METROPOLITAN GOVERNMENT OF NASHVILLE AND DAVIDSON COUNTY

STAFF RECOMMENDATION 1114 Chapel Avenue July 17, 2013

Application: New construction – addition to outbuilding
District: Eastwood Neighborhood Conservation Zoning Overlay
Council District: 06
Map and Parcel Number: 083020A00100CO
Applicant: Kim Kennedy, Architect
Project Lead: Sean Alexander, sean.alexander@nashville.gov

1 ROOF PLAN

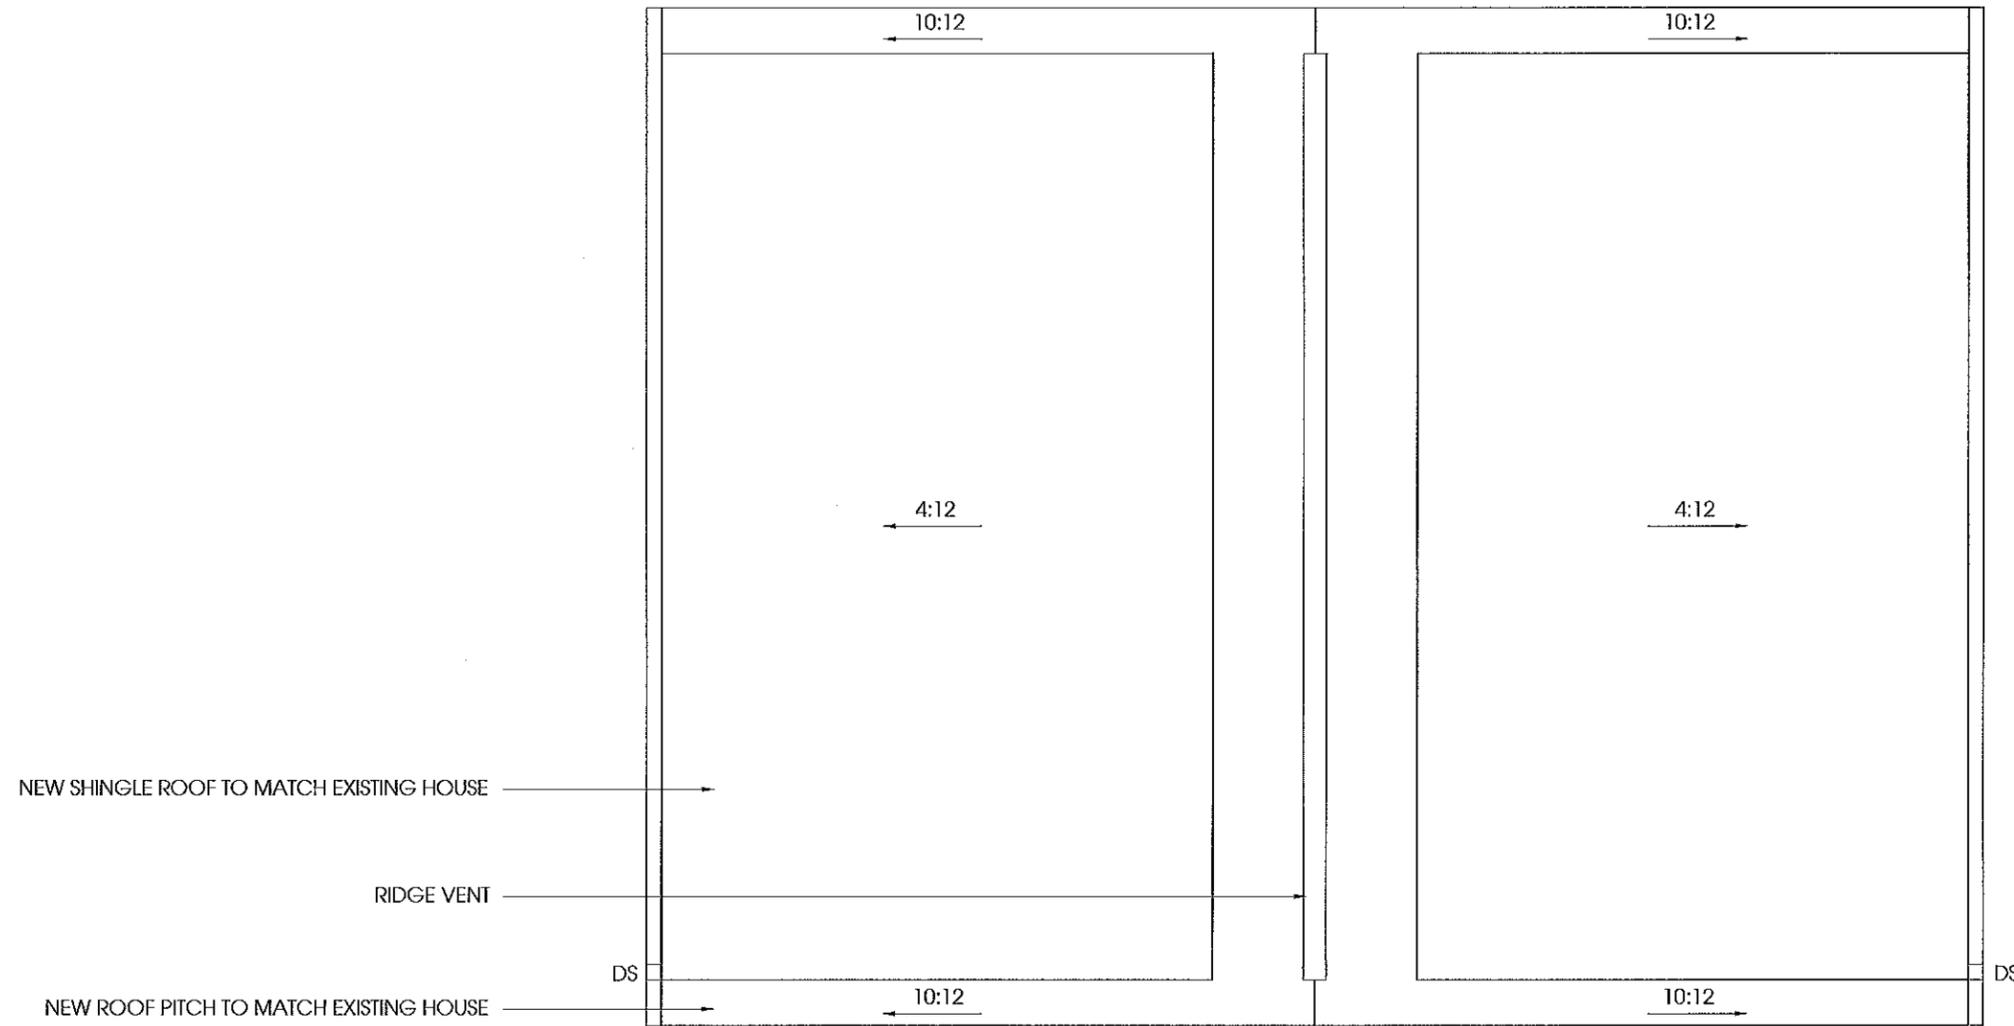
The roof of the enlarged building will be a front-oriented gable with a pitch of 10:12. This is slightly steeper than the existing 8:12 pitch, but is not incompatible with the roof of the primary building. There will be shed-roofed dormers on each side of the building with a 4:12 pitch. These roof forms are appropriate for an accessory building and meet guideline II.B.1.e.

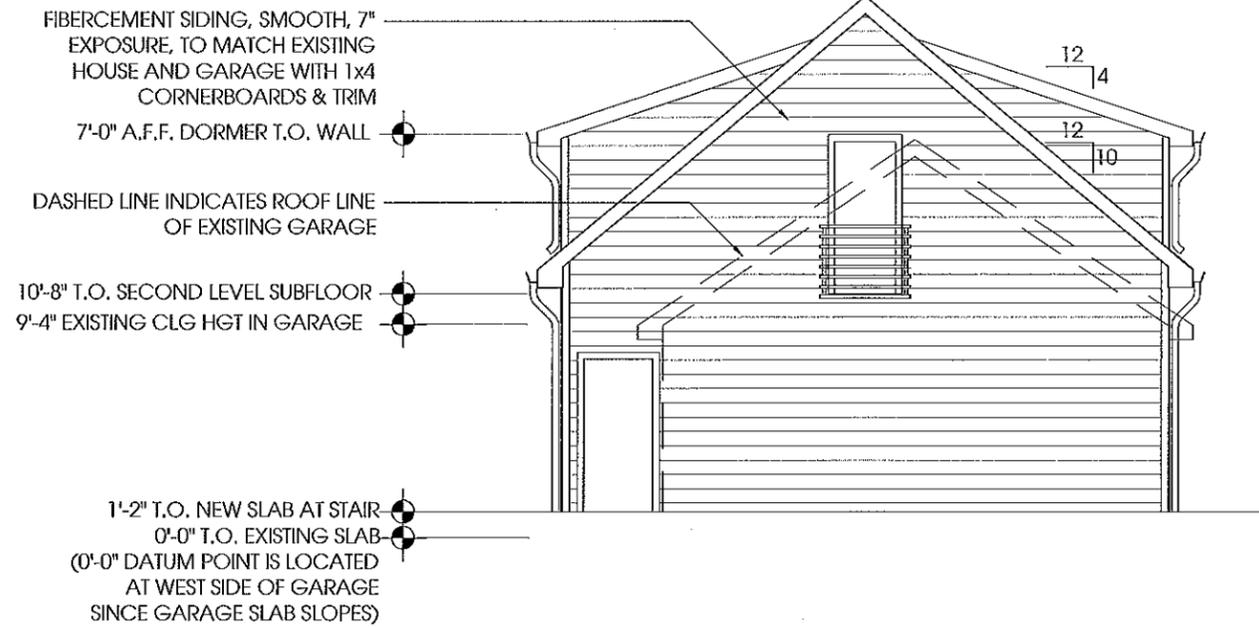
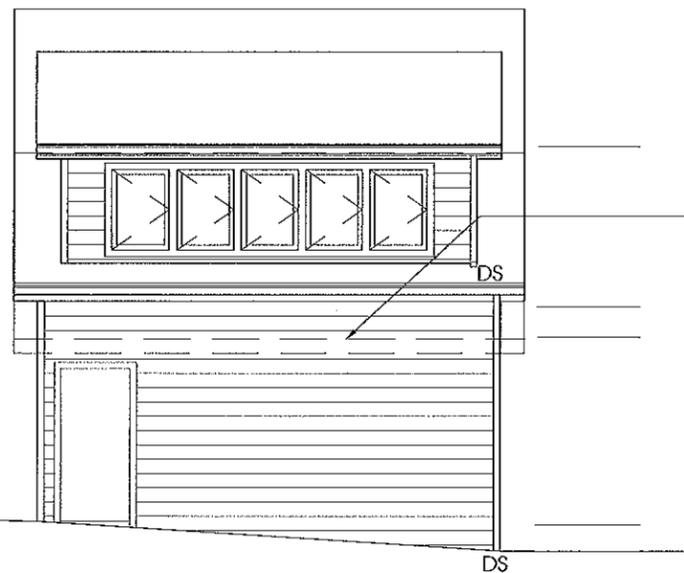
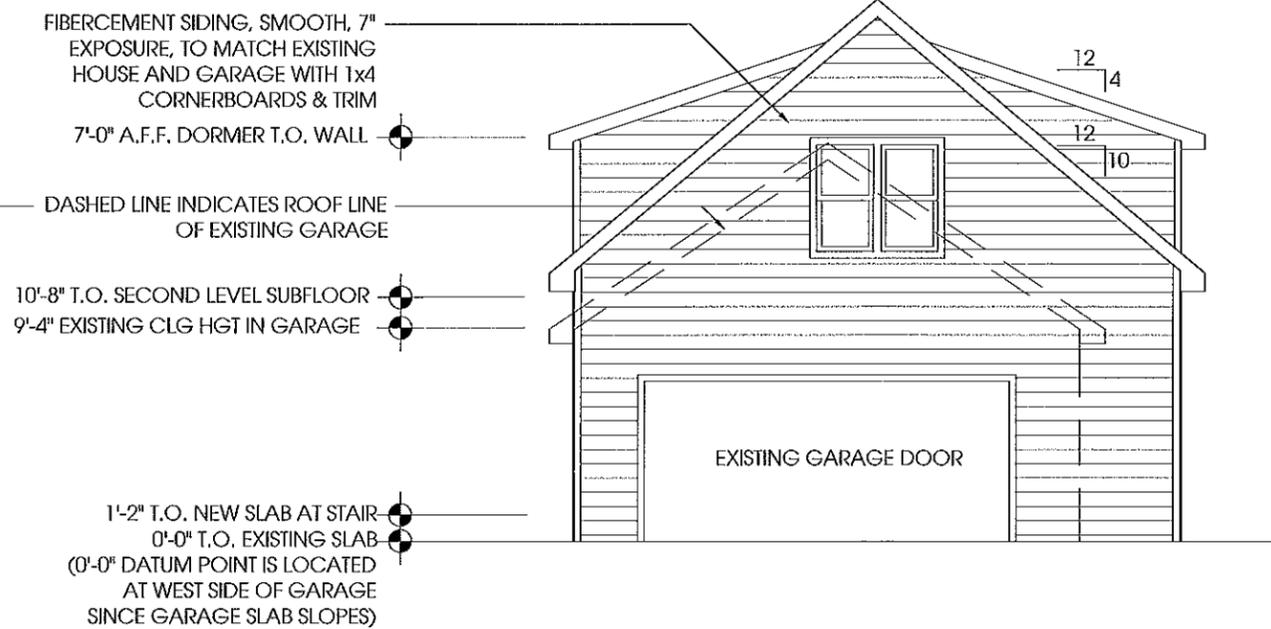
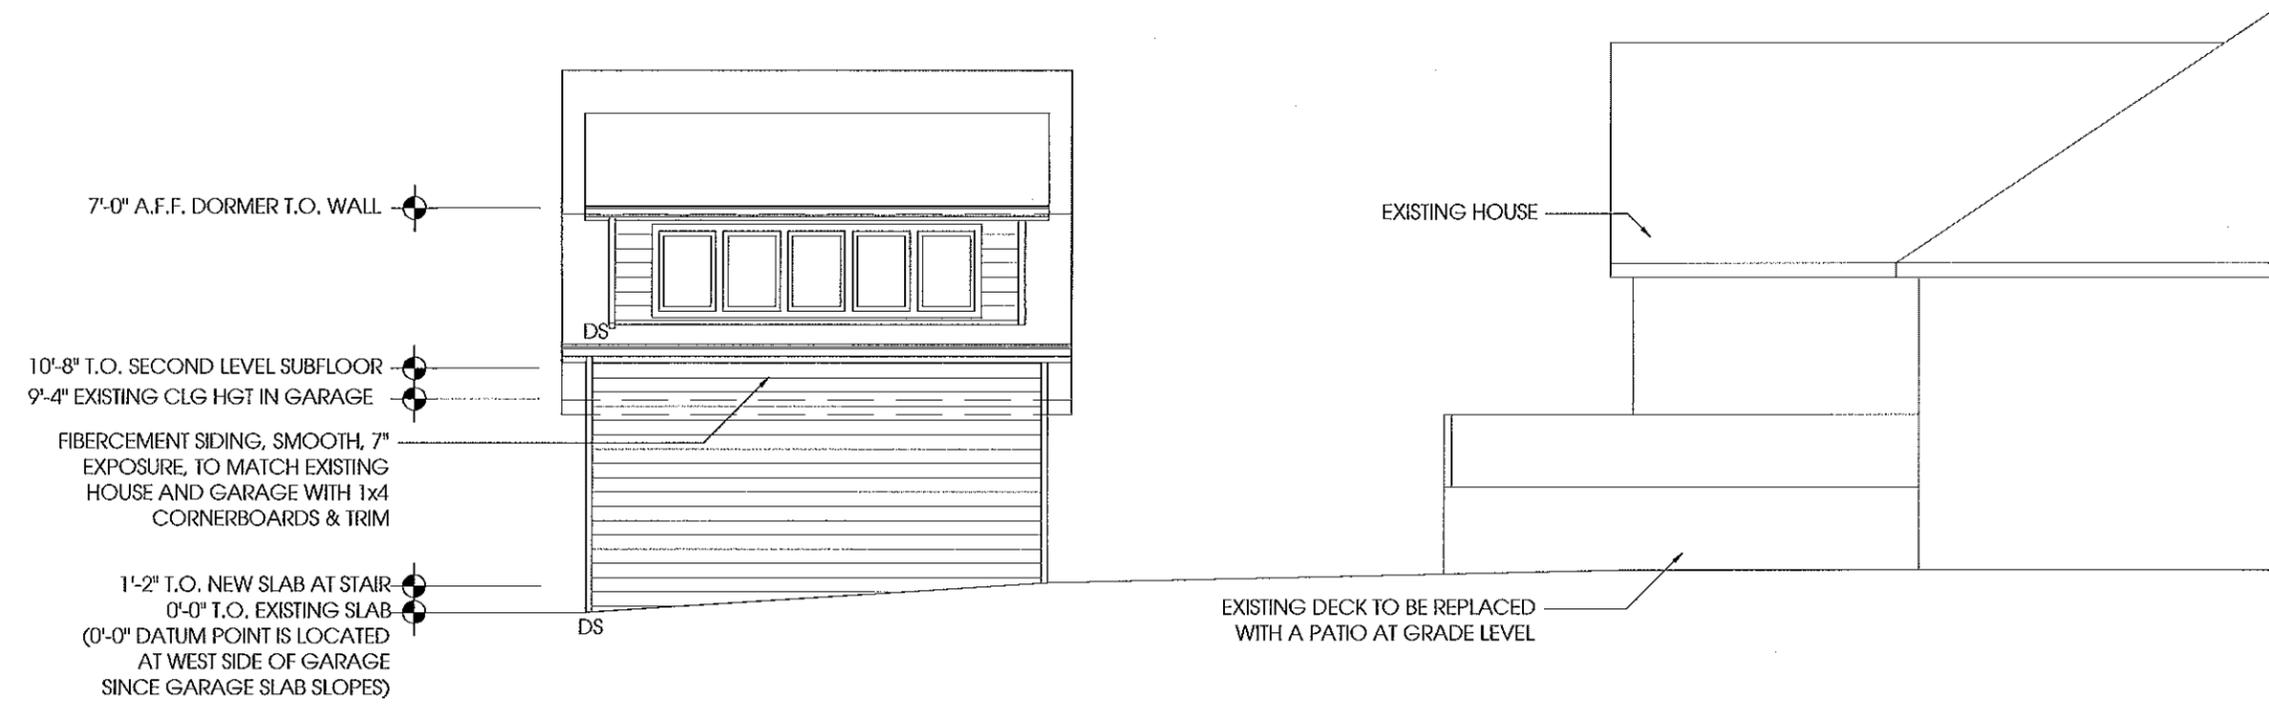
The gabled roof and trusses of the existing garage will be removed in order to construct a second floor, knee-walls, and a new roof with dormers. The height of the building will be increased from seventeen feet (17') to twenty-four feet (24') when completed. The height of the eaves will be raised from nine feet (9') above grade to eleven feet (11').

The exterior of the building is currently clad with cement-fiber siding with a seven inch (7") exposure, which matches the siding on the house. The new sections of the outbuilding will be clad with the same material. The roof will be composite shingles matching the roof on the house. The materials of the windows and doors are not known.

The proportion and rhythm of openings of the enlarged building will be typical of historic accessory buildings and will meet guideline II.B.1.g. The materials of the windows and doors are not known.

Staff recommends approval of the addition to the existing outbuilding with the condition that the materials of the windows and doors are approved administratively. With that condition met, staff finds that the building will meet the applicable design guidelines for the Eastwood Neighborhood Conservation Zoning Overlay.
